DATE: 11 May 2020
SUBJECT: Duplication of FPA on Approaches - No Longer Mandatory
Impacted: Flex NavDB Airbus Customers
Cycles: 2006 – Effective Date 21 May 2020

Example: LIRF RNV16R (Vertical Angle not Duplicated – “Dive and Drive” Construction)

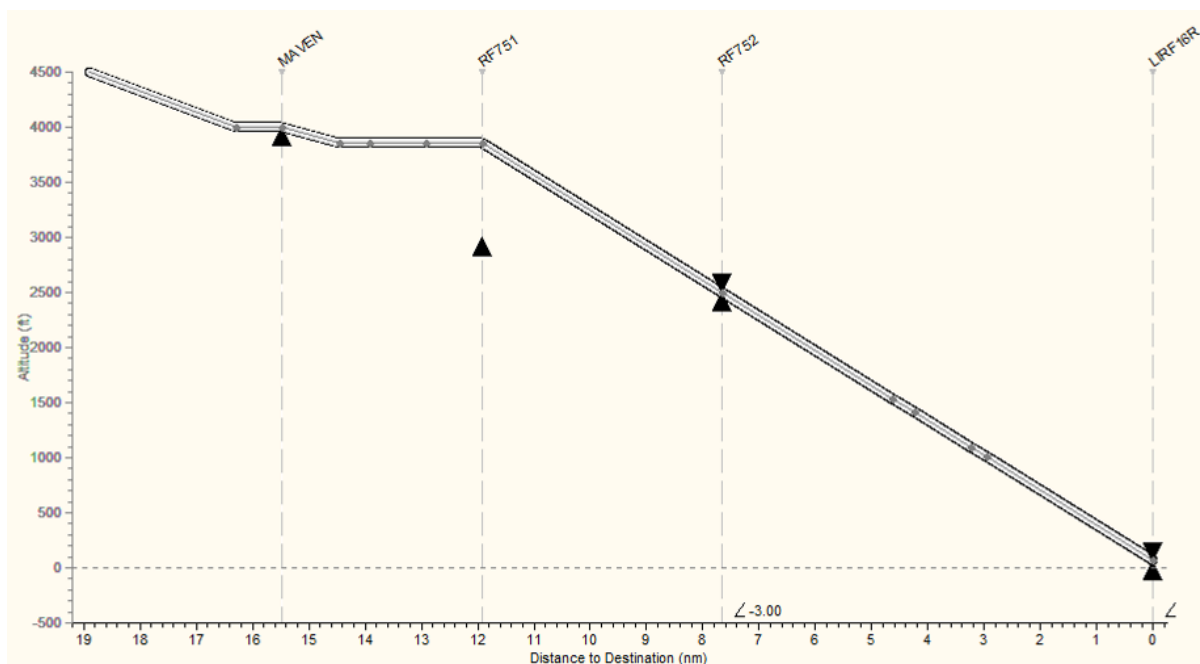
Flight Management System (FMS) Final Approach vertical construction is based on Altitude constraints and Vertical Angle. Historically, some of the Type 1 and DAT 1 Data Suppliers have not applied the Vertical Angle to every leg of the Final Approach. Step-Down Fixes and Final Approach Fix are some examples. The result is an inefficient “Dive and Drive” type of construction.

Example: LIRF RNV16R (Vertical Angle not Duplicated – CDA Construction)

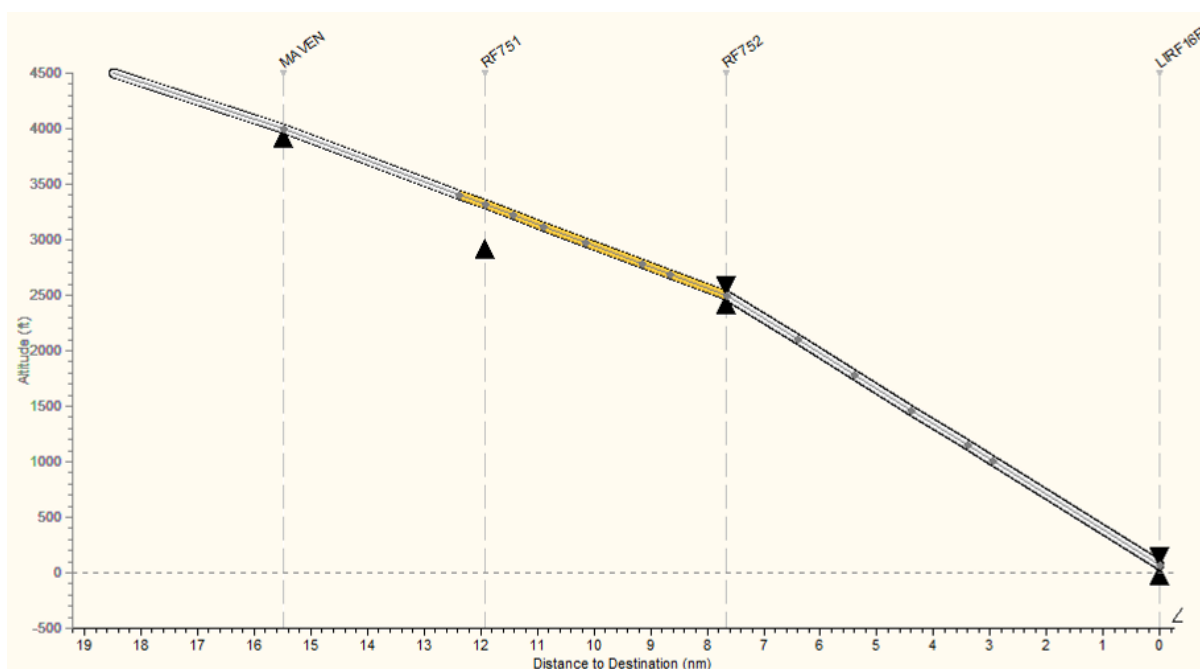
With modern Approach construction, the FMS is more robust and avoids the “Dive and Drive” construction. An example is the Continuous Descent/Approach (CDA) construction. The need for this DM no longer exists with some of our most recent FMS versions.

DMs are mandatory whereas Operator Requested Changes (ORCs) are optional items that can be applied or not as requested by the customer. Airbus and Honeywell have decided to change the DM to an ORC for all Flex NDBs and have the Vertical Angle duplication no longer applied on any NavDBs generated for standards with CDA available: Single Aisle A/C Operators with the H3 standard (PS4087600-907) or A350 Operators. NavDBs for Long Range A/C Operators, Single Aisle A/C Operators with any standard prior to H3, and A380 Operators will

continue to have the Vertical Angle duplication applied. However, for any of the below listed FMS P/Ns, the customer can request the Vertical Angle duplication to be applied or not by contacting Aviation.Services@Honeywell.com before the cutoff date for the cycle you wish to receive the change.

Example: LIRF RNV16R (Vertical Angle not Duplicated – CDA Construction)

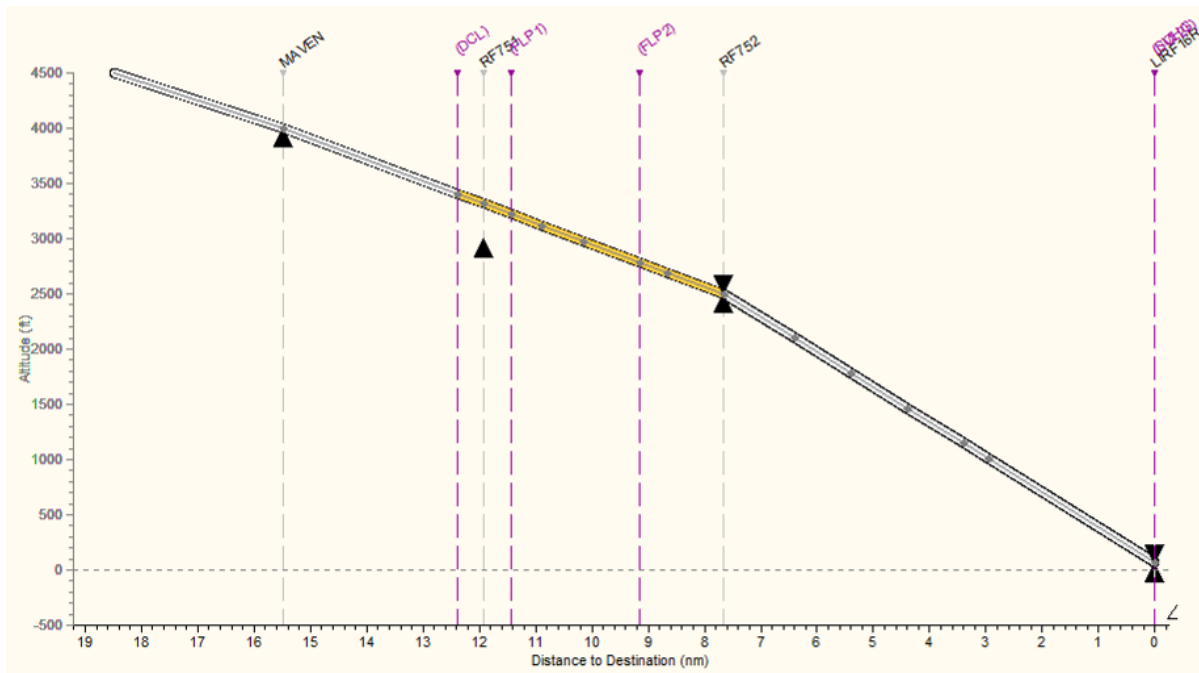
Q2: What is the benefit of removing Vertical Angle duplication from single-aisle H3 and A350 with CDA enabled?

A2: The Vertical Angle duplication extends the -3° construction upstream the Final Approach. In doing so, it prevents the use of a shallow slope which is more beneficial for energy management in this critical phase of flight.
